BID ADDENDUM NO. 1

PROJECT TITLE: Shelter Creek Sewer Main Replacement Project

PROJECT NO. 31016

DATE: 8/21/2025

Appendix B – GIS MAPS
Drawing Sheet 10

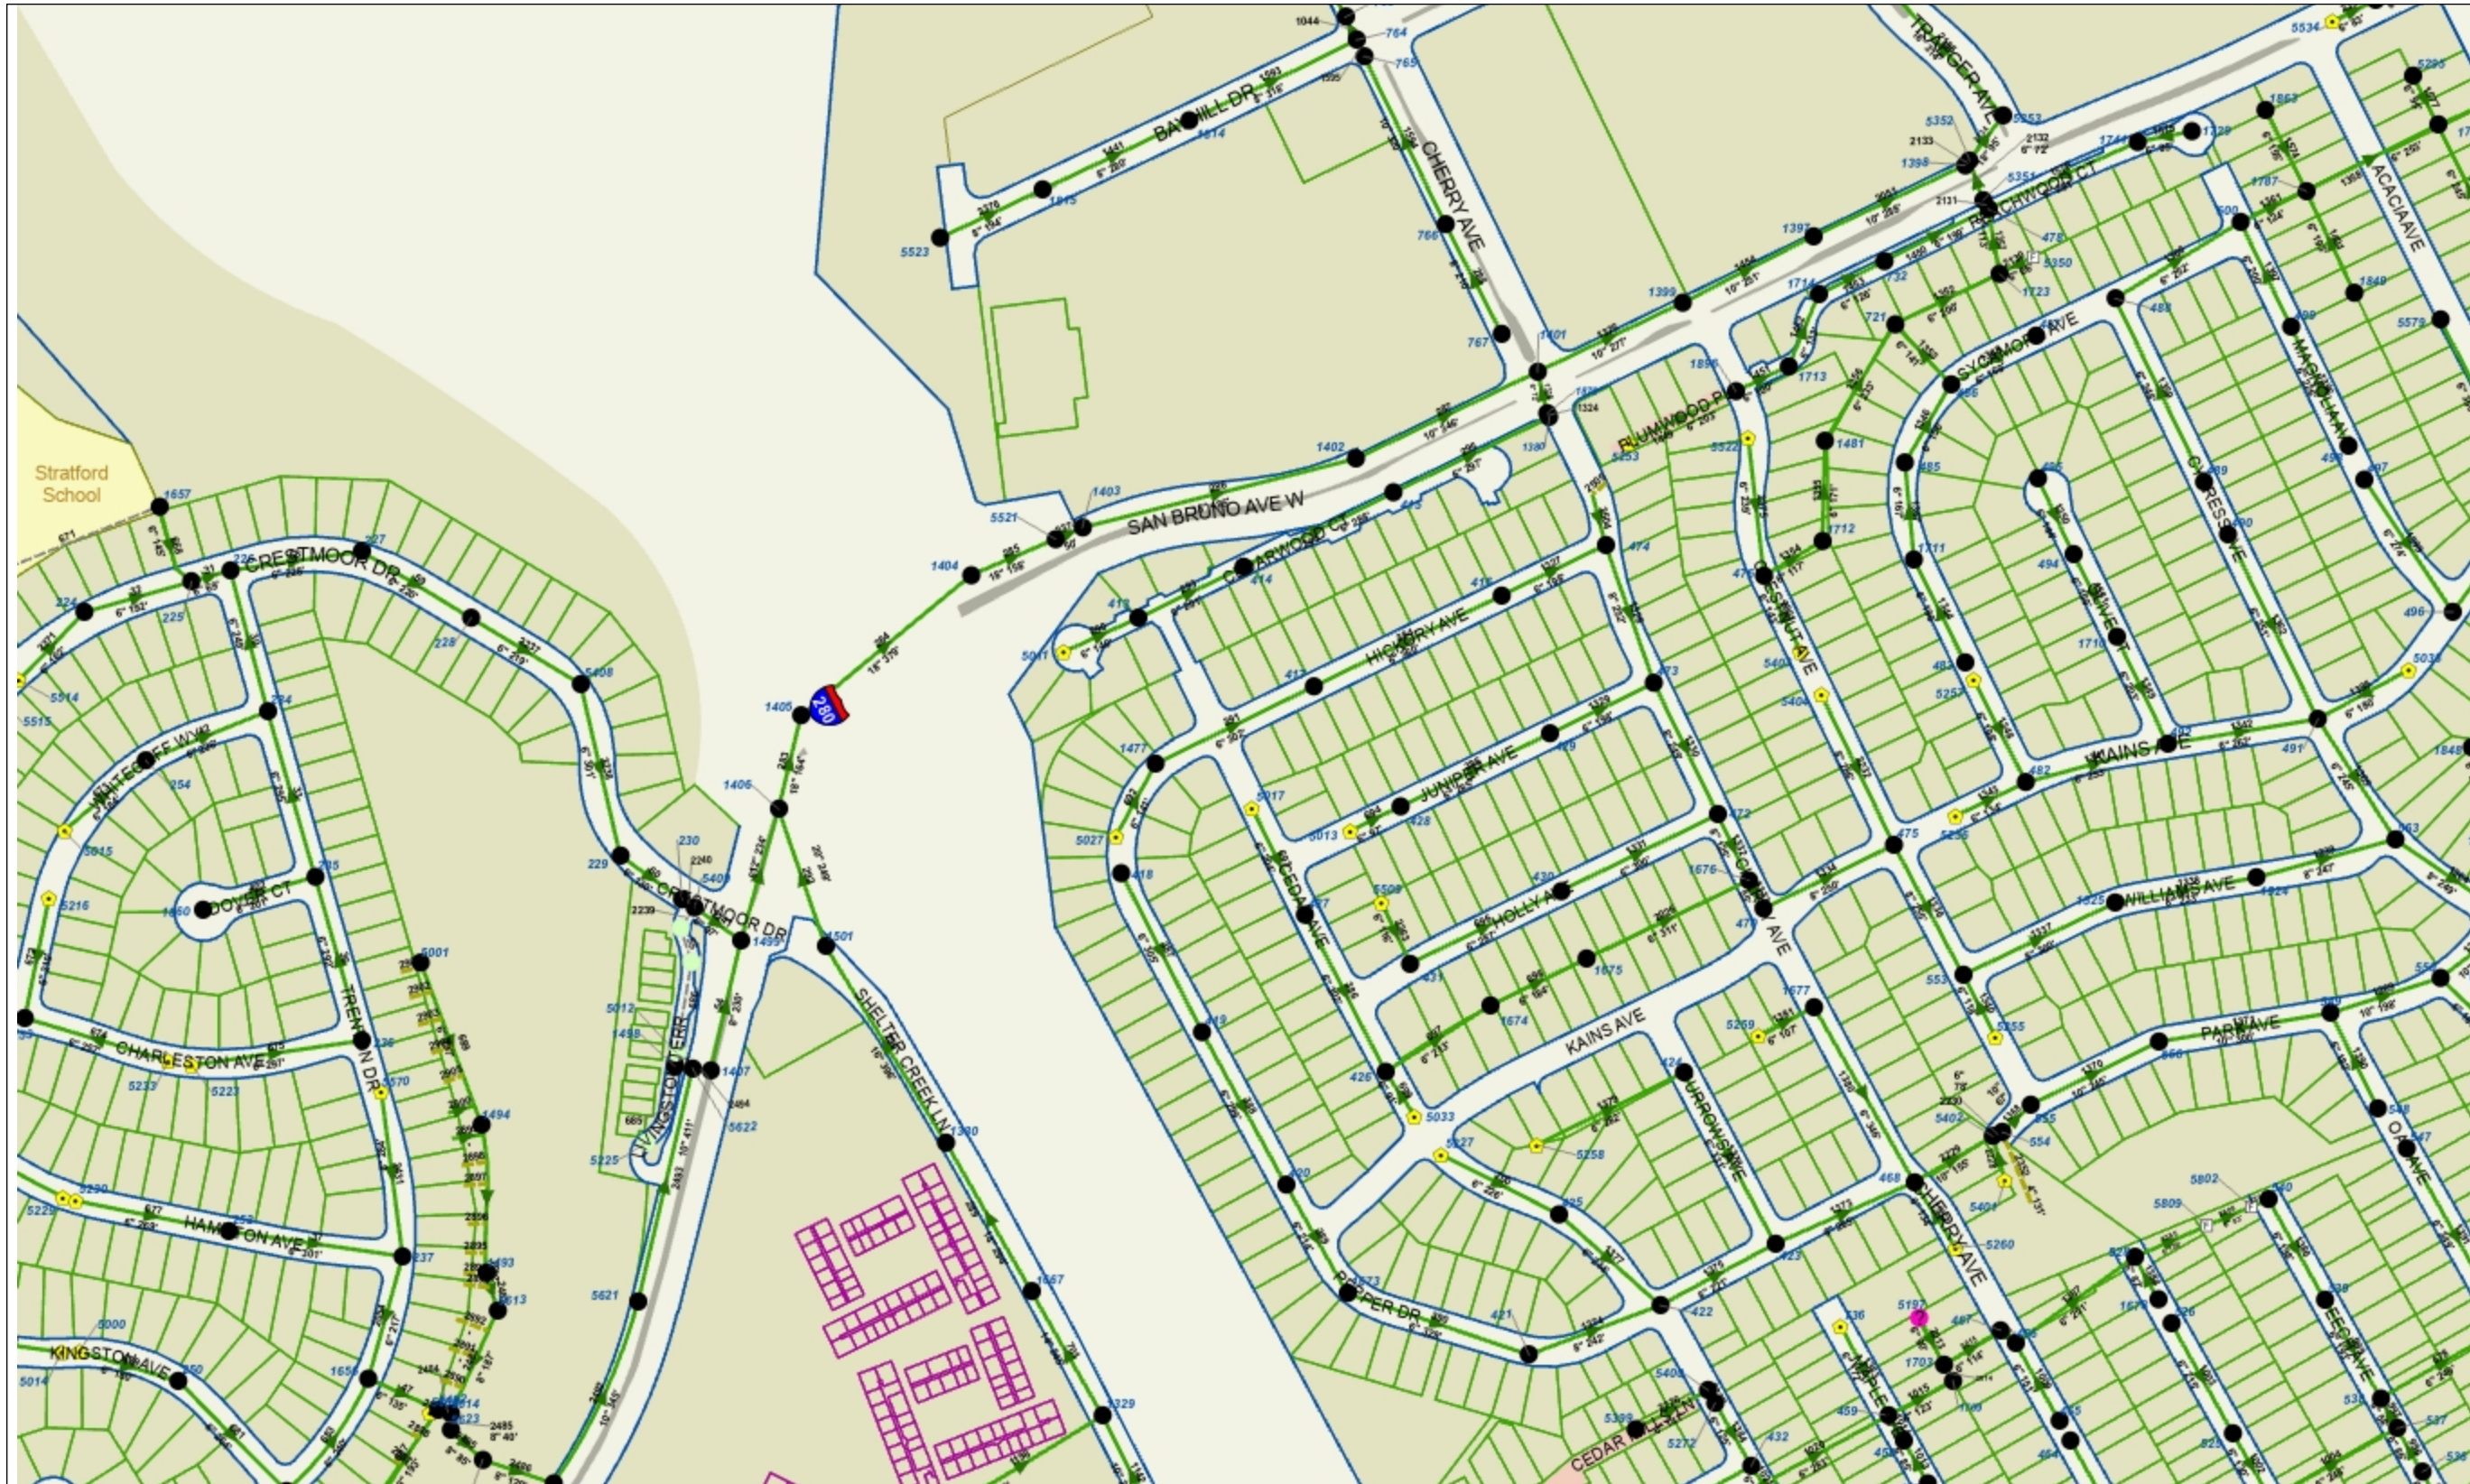
1. Drawing Sheet 10 shall be deleted and be replaced by the attached Drawing Sheet 10 of this Bid Addendum No. 1.

10. On the alternate 54" CIPP, it calls for a transition at a concrete collar to the 60". The plans state to install a seamless smooth transition. Please remove language and clarify problem trying to solve.

Response: See attached Drawing Sheet 10 of this Bid Addendum No. 1.
